SUBJECT: NORTH ANNA UNIT 1 - ISSUANCE OF AMENDMENT RE: HEATUP AND
COOLDOWN CURVES (TAC NO. 72060)

Amendment No. 117
License No. NPF-4

ATTACHMENT TO LICENSE AMENDMENT NO. 117

Figure 3.4.2 Reactor Coolant System Pressure-Temperature Heatup Limitations

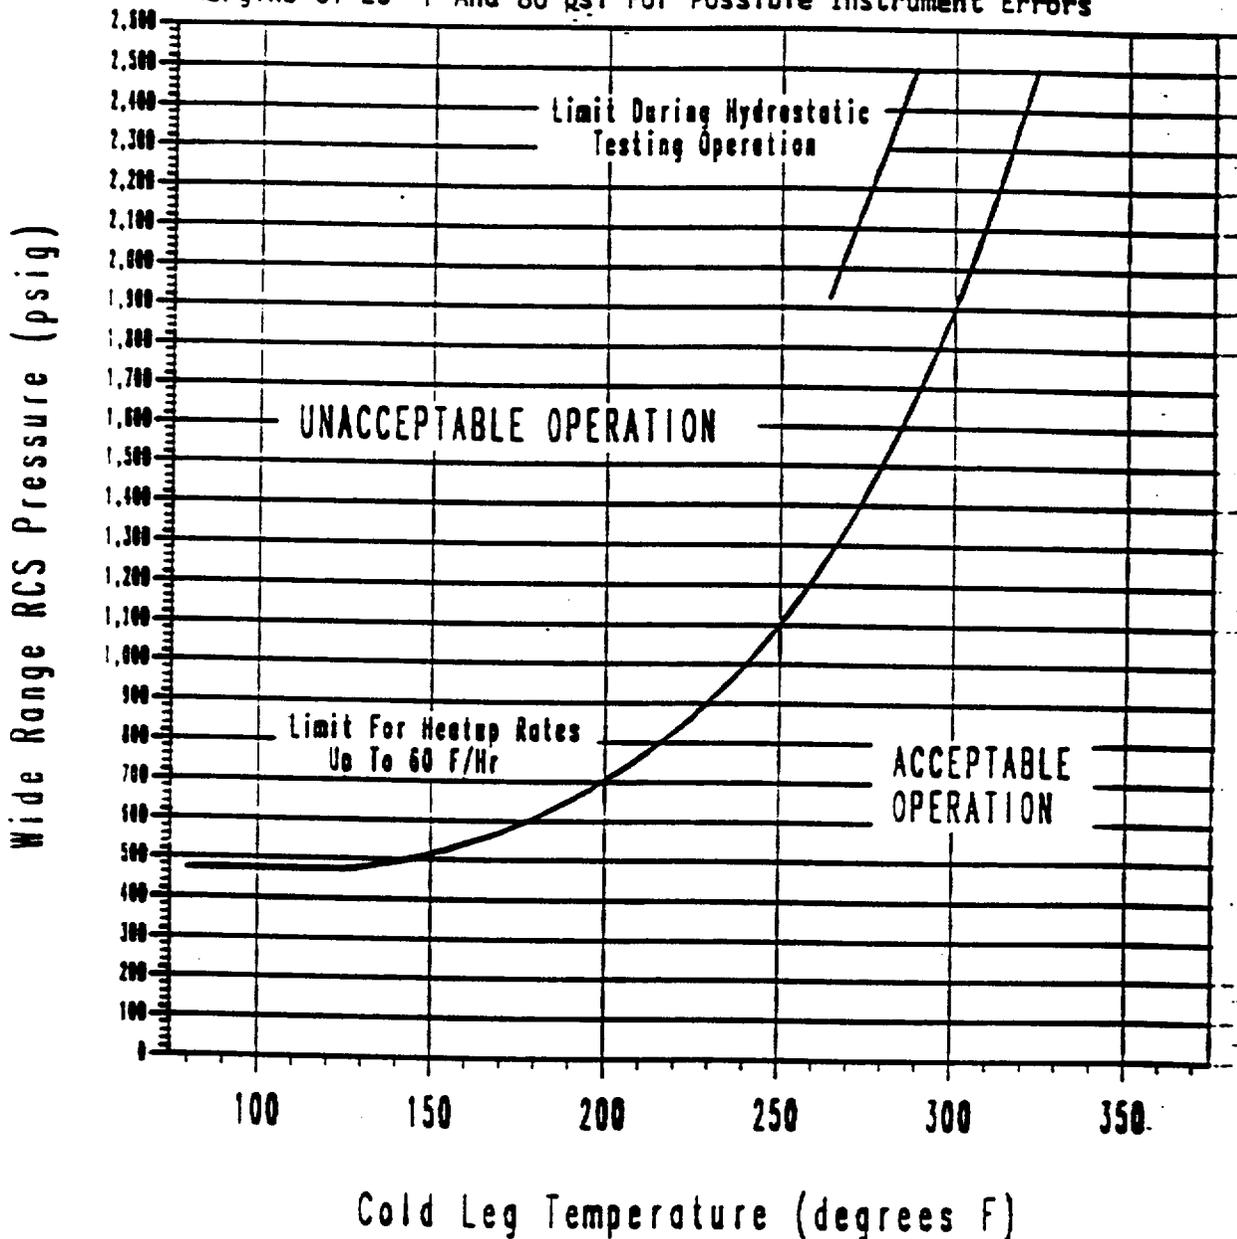
This amendment revises the heatup and cooldown curves and associated low temperature overpressurization setpoints to be valid for a period up to 10 effective full power years. In addition, the staff finds that the submittals supporting your amendment request comply with Generic Letter 88-11 and the methods specified in Regulatory Guide 1.99, Revision 2.

Curves Applicable For Service Periods Up To 10 EFPY And Contain Margins Of 20 °F And 80 psi For Possible Instrument Errors

The heatup limit curve, Figure 3.4.2, is a composite curve which was prepared by determining the most conservative case, with either the inside or outside wall controlling, for any heatup rate up to 60°F per hour. The cooldown limit curves of Figure 3.4.3 are composite curves which were prepared based upon the same type analysis with the exception that the controlling location is always the inside wall where the cooldown thermal gradients tend to produce tensile stresses while producing compressive stresses at the outside wall. The heatup and cooldown curves were prepared based upon the most limiting value of the predicted adjusted reference temperature at the end of 10 EFPY. The adjusted reference temperature was calculated using results from a capsule removed after the sixth fuel cycle. The results are documented in Westinghouse Reports WCAP-11777, February 1988 and WCAP-11791, May 1988.

The pressure-temperature limit lines shown on Figure 3.4.2 for inservice leak and hydrostatic testing have been provided to assure compliance with the minimum temperature requirements of Appendix G to 10 CFR 50. The minimum temperature for criticality specified in T.S. 3.1.1.5 assures compliance with the criticality limits of 10 CFR 50 Appendix G.

Figure 3.4.3 Reactor Coolant System Pressure-Temperature Cooldown Limitations

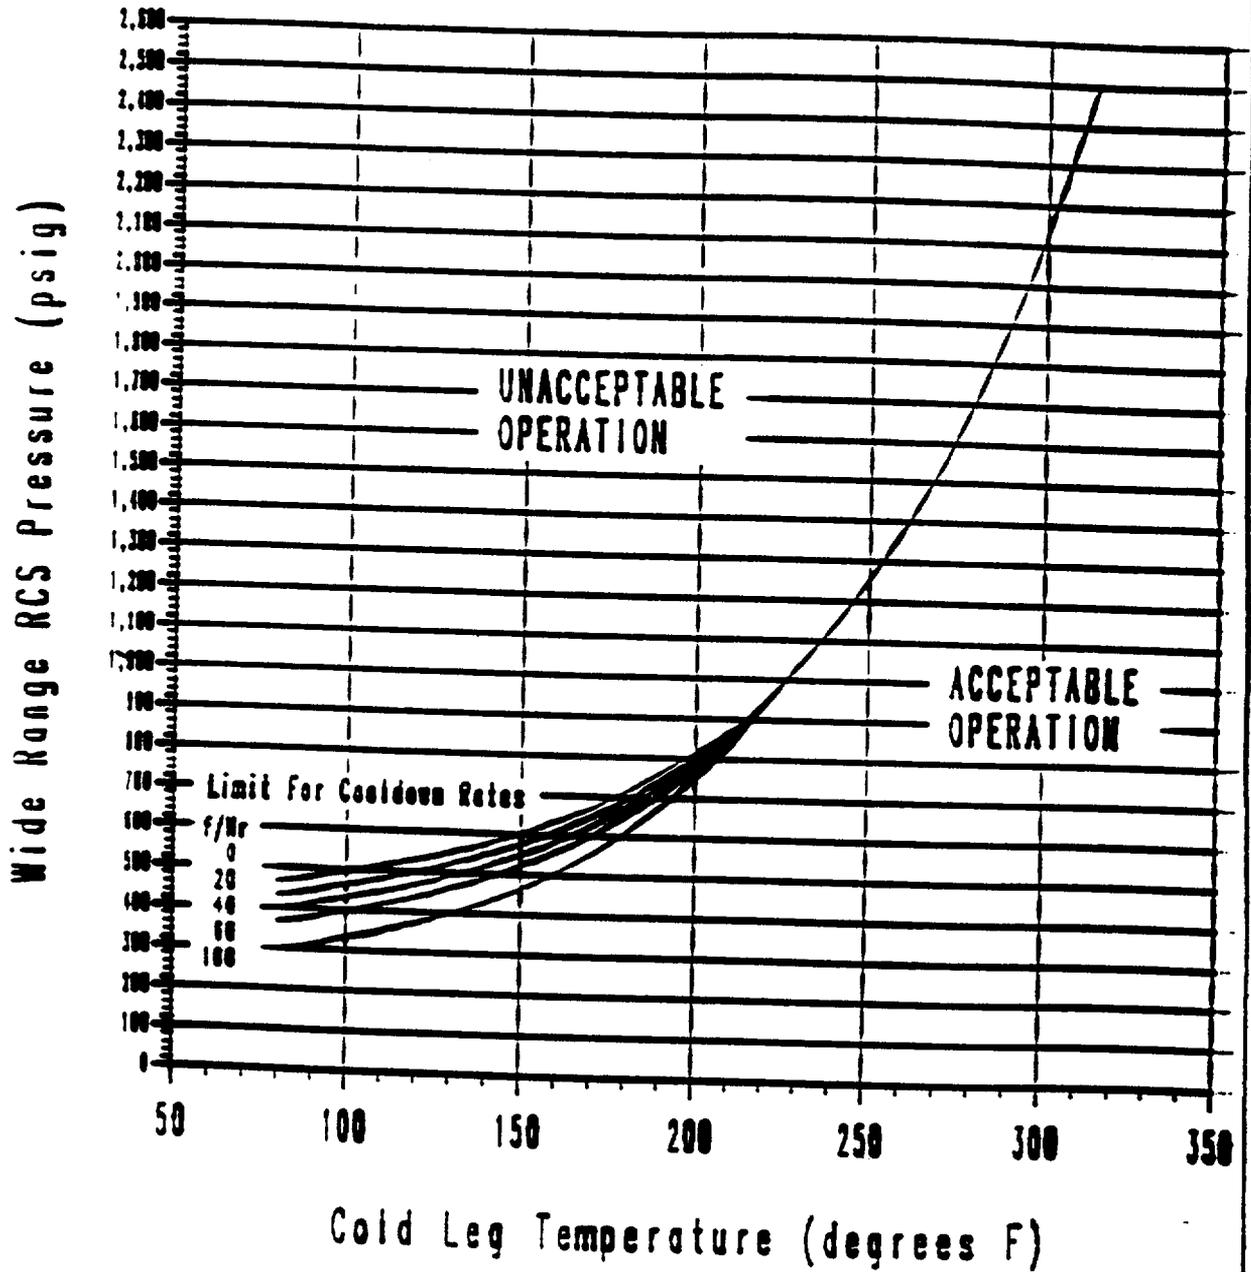
Curves Applicable For Service Periods Up To 10 EPY And Contain Margins Of 20 °F And 80 psi For Possible Instrument Errors
